DAVIS-BESSE NUCLEAR POWER STATION
UNIT 1

IMPROVED TECHNICAL SPECIFICATION CONVERSION LICENSE AMENDMENT REQUEST

VOLUME 9 (Rev. 1)

SECTION 3.4 - REACTOR COOLANT SYSTEM (RCS)

Figure 3.4-2

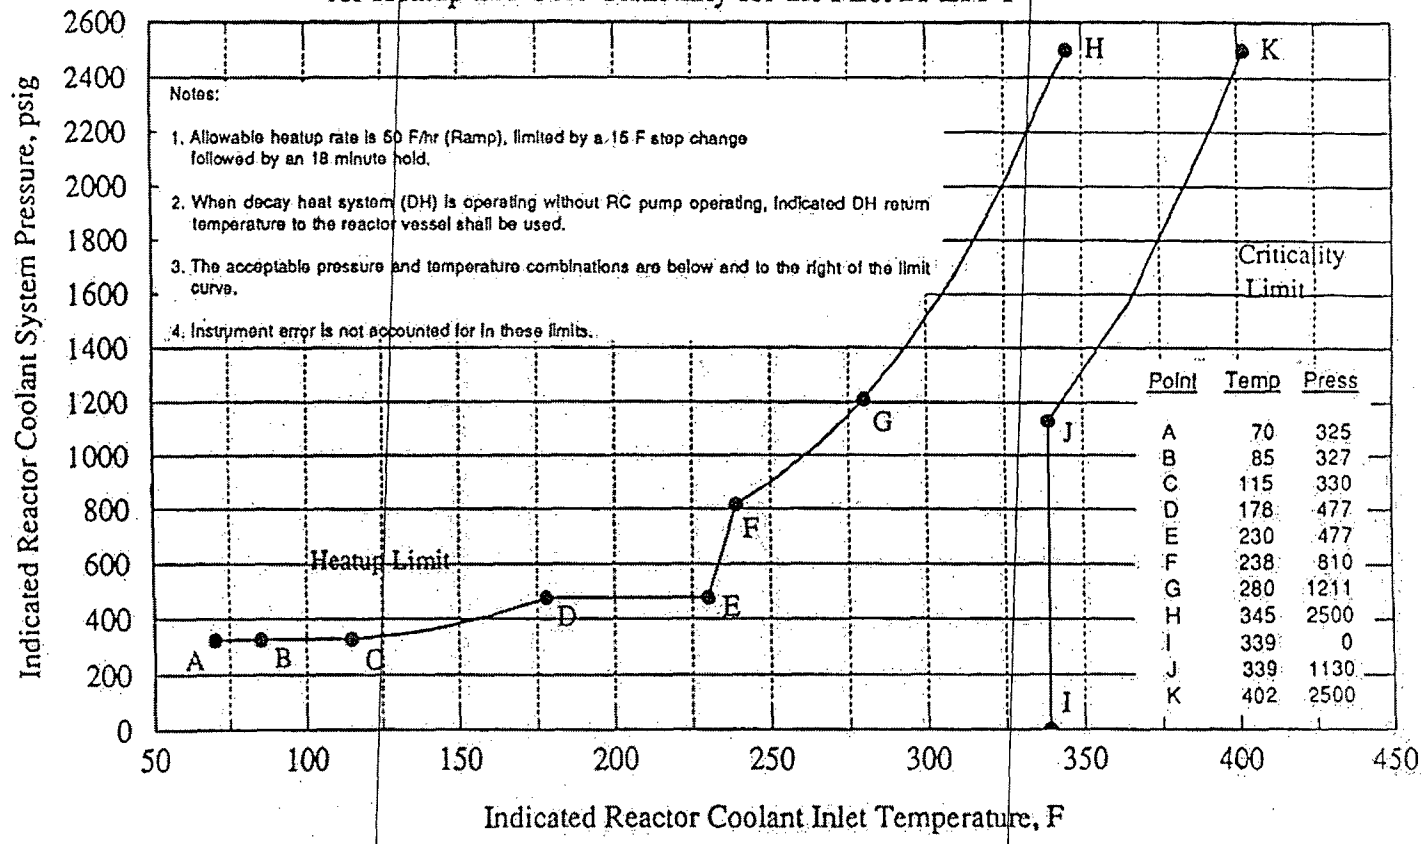
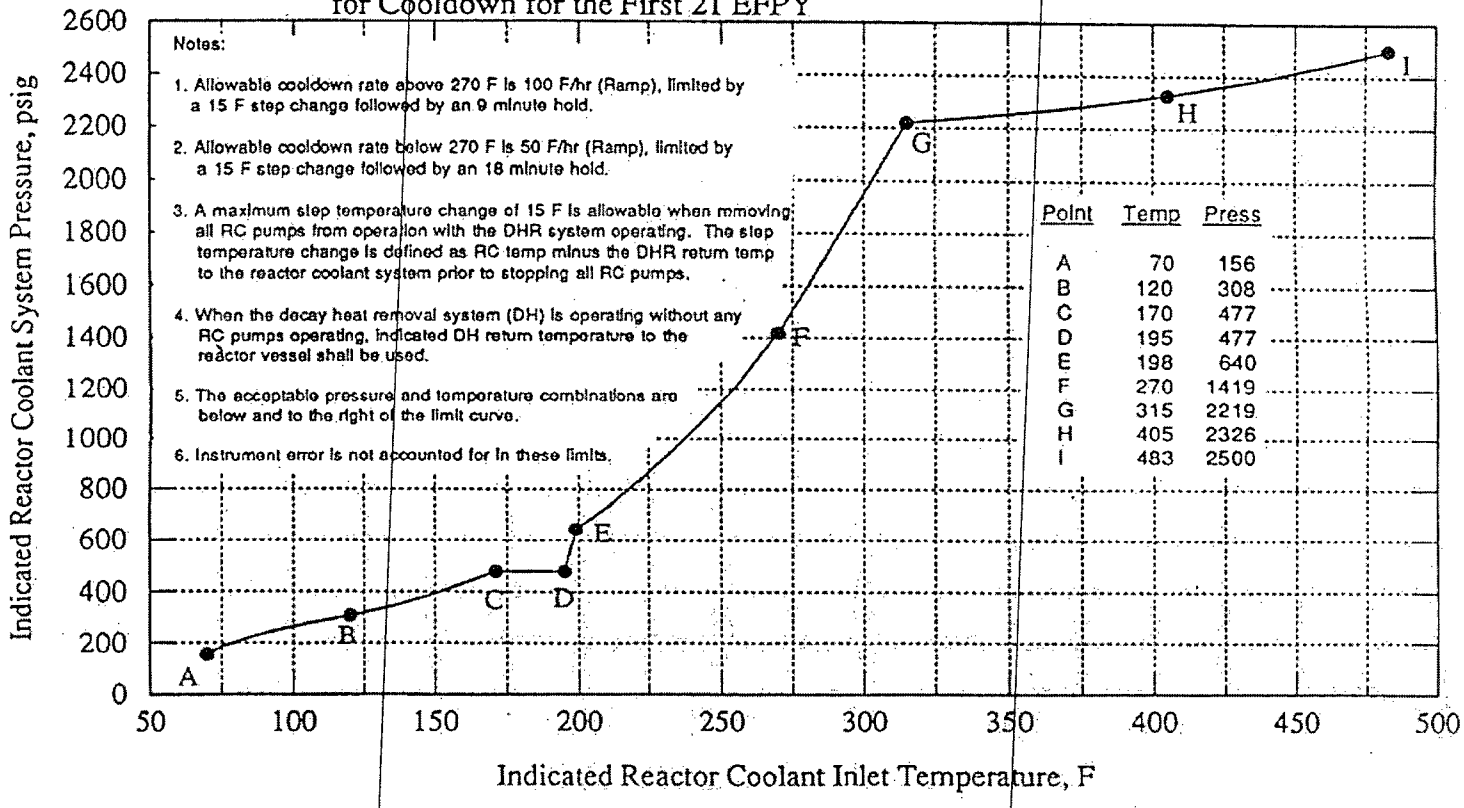
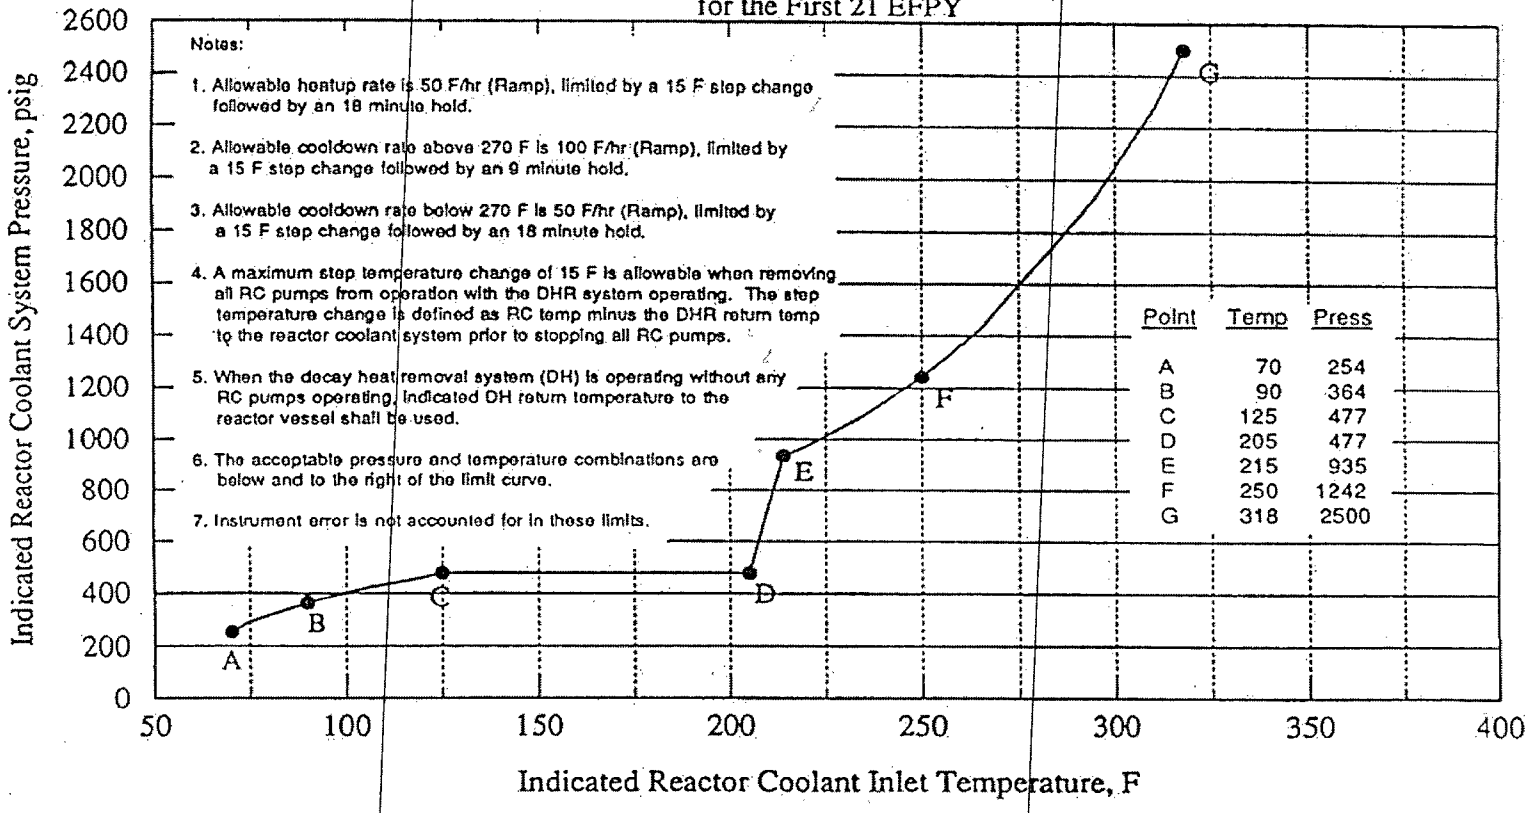
The removal of these figures, heatup rate, and cooldown rate from the Technical Specification to the PTLR is acceptable because the PTLR is developed and utilized under NRC-approved methodologies, which will ensure that the RCS pressure and temperature limits for heatup, cooldown, low temperature operation, criticality, and hydrostatic testing as well as heatup and cooldown rates are met. This type of information is not necessary to be included in the Technical Specification to provide adequate protection of public health and safety. The ITS still retains the RCS P/T Limit requirements. The methodologies used to develop the parameters in the PTLR have obtained prior approval by the NRC. Also, this change is acceptable because the removed information will be adequately controlled in the PTLR under the requirements provided in ITS 5.6.4, "Reactor Coolant System (RCS) PRESSURE AND TEMPERATURE LIMITS REPORT (PTLR)." ITS 5.6.4 ensures that the applicable RCS pressure and temperature limits are met. This change is designated as a less restrictive removal of detail change because the detailed P/T limits are being removed from the Technical Specifications.

Figure 3.4.12-1

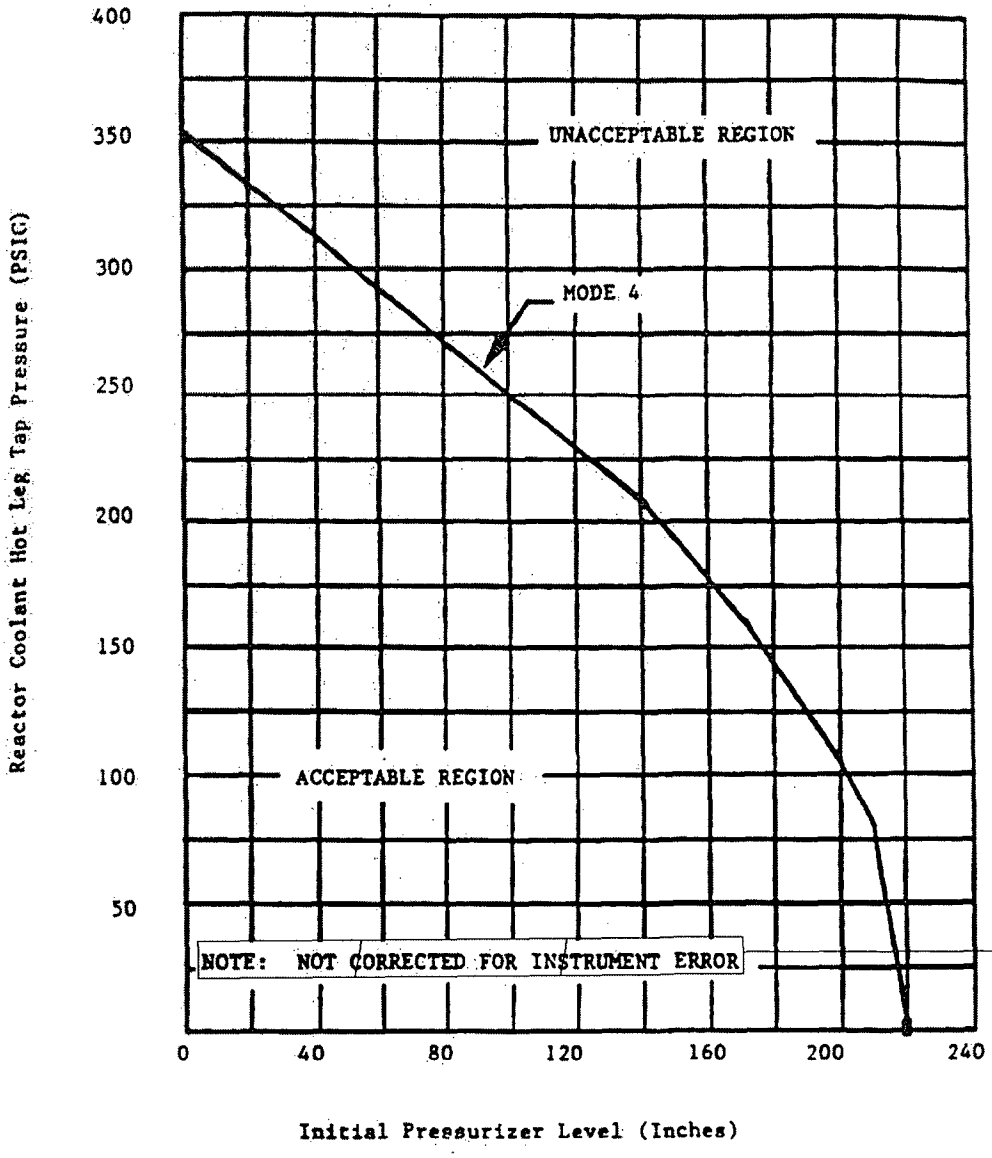
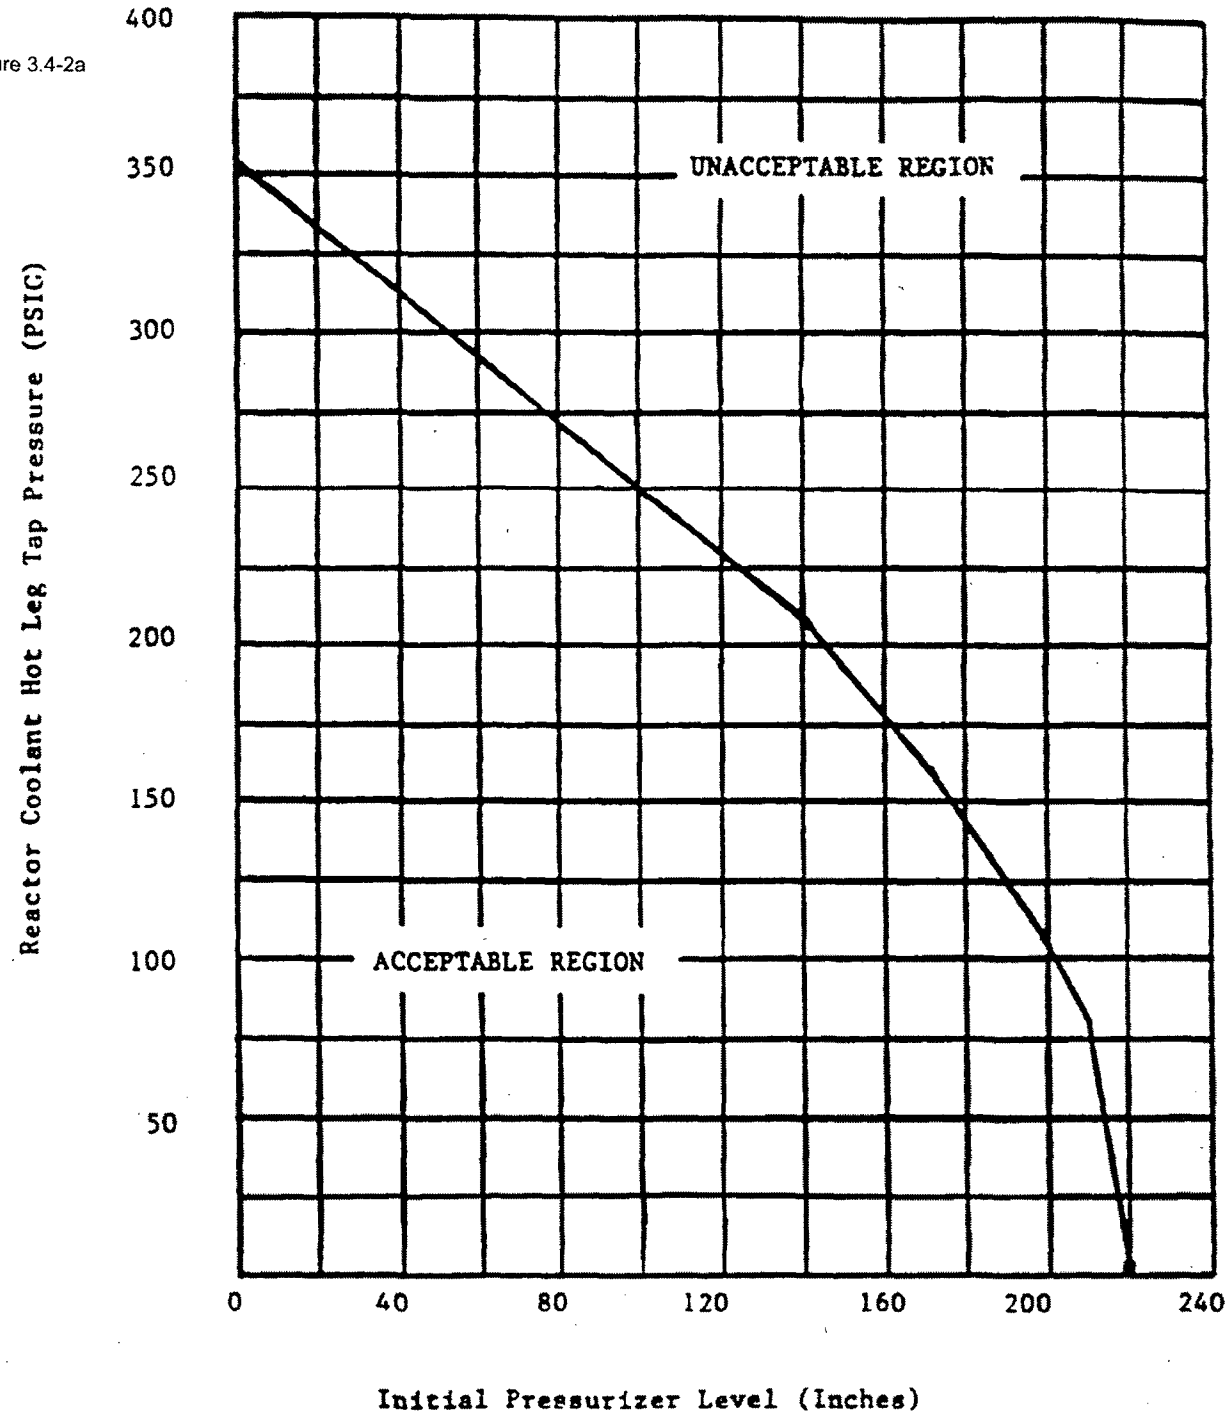
LA01 *(Type 1 – Removing Details of System Design and System Description, Including Design Limits)* CTS 3.4.2 is modified by a note (footnote *) that states that the decay heat removal relief valve lift setting pressure shall correspond to normal operating temperature and pressure. CTS LCO 3.4.2, Actions A, B, and C, and Surveillance Requirement 4.4.2 provides specific valve numbers for certain Decay Heat Removal System valves. CTS 3.4.2 Action c requires power to the valve operators be removed at the motor control centers. CTS Figures 3.4-2a and 3.4-2b (used when a Decay Heat Removal System relief valve is inoperable) include a Note that states the Figures are not corrected for instrument error. ITS 3.4.12 does not include these details. Furthermore, ITS 3.4.12 uses the plant specific names for the associated valves, and requires control power to be removed from the RCS to DHR system isolation valves. This changes the CTS by moving the valve numbers, the information concerning the lift settings, the details concerning how to remove power from the valves, and that the Figures are not corrected for instrument error to the Bases.

Figure 3.4.12-2

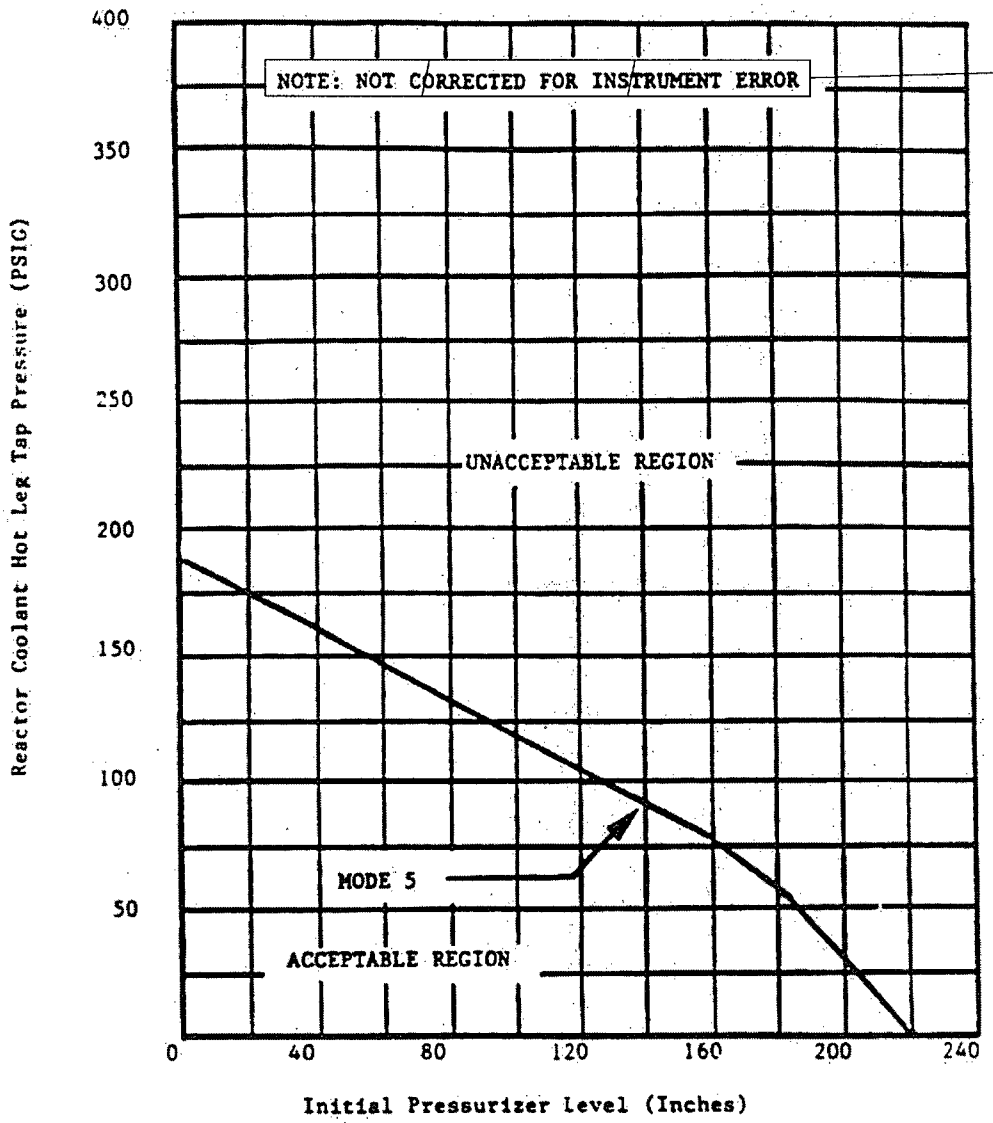
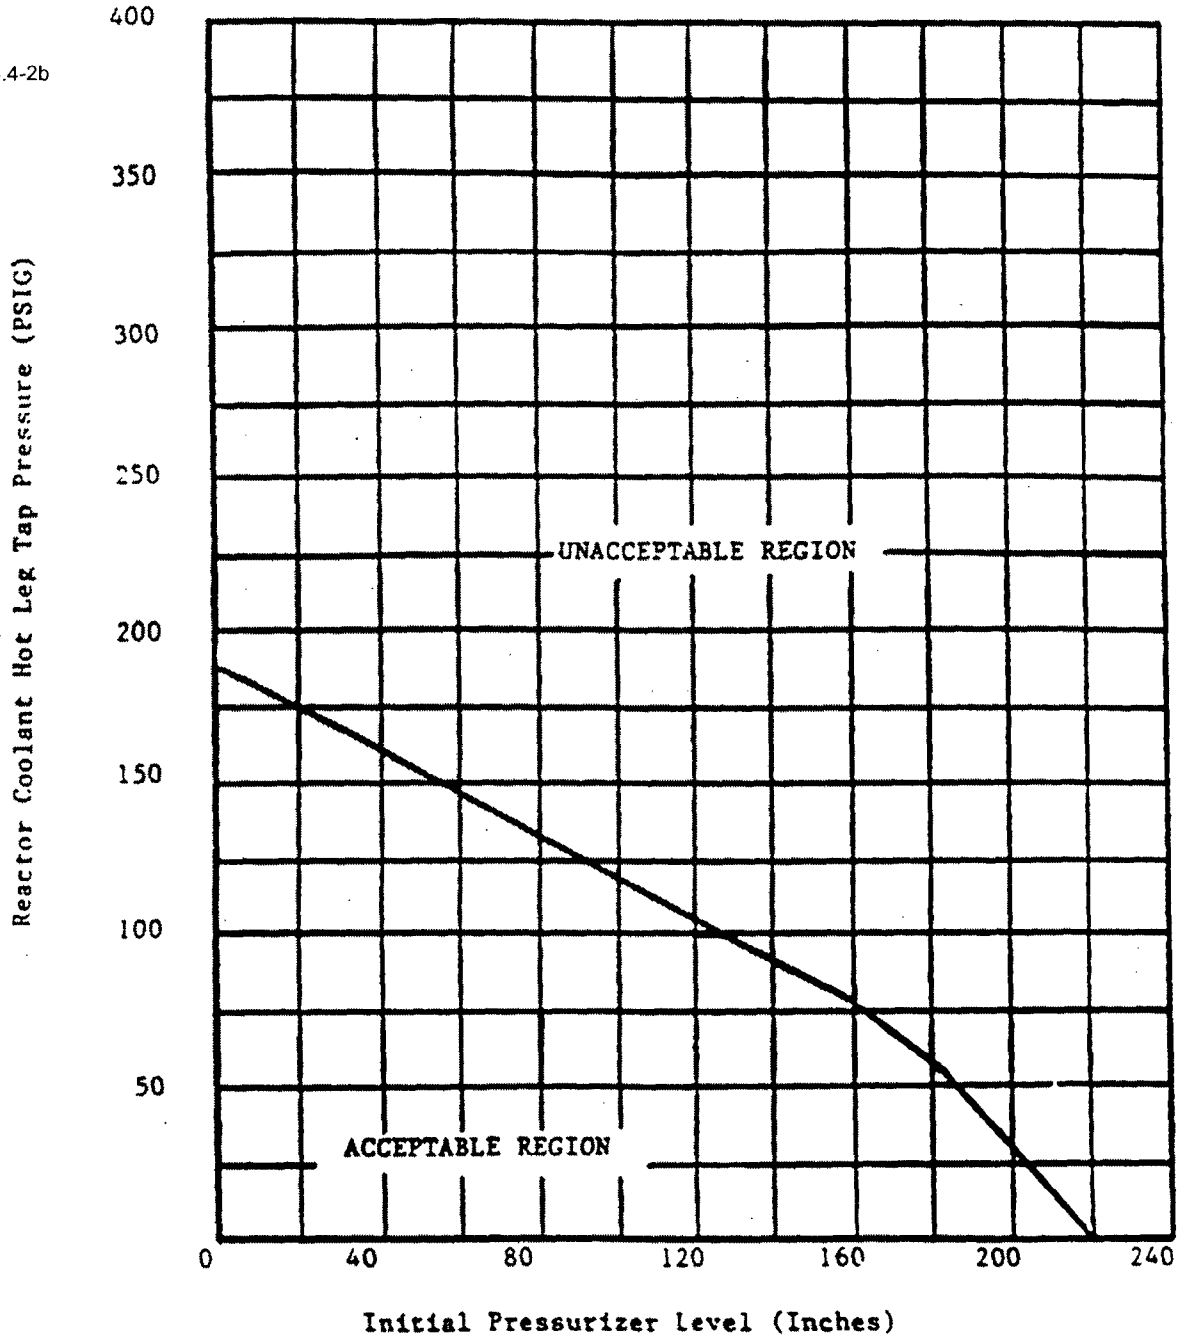
M01 CTS 3.4.2 is applicable in MODES 4 and 5. CTS Figure 3.4-2b is applicable in MODE 5. ITS LCO 3.4.12 is applicable in MODES 4 and 5, and MODE 6 when the reactor vessel head is on. In addition, Figure 3.4.12-2 is applicable in MODE 5 and MODE 6 when the reactor vessel head is on. This change expands the Applicability of the low temperature overpressure protection components to be OPERABLE in MODE 6 when the reactor vessel head is on.
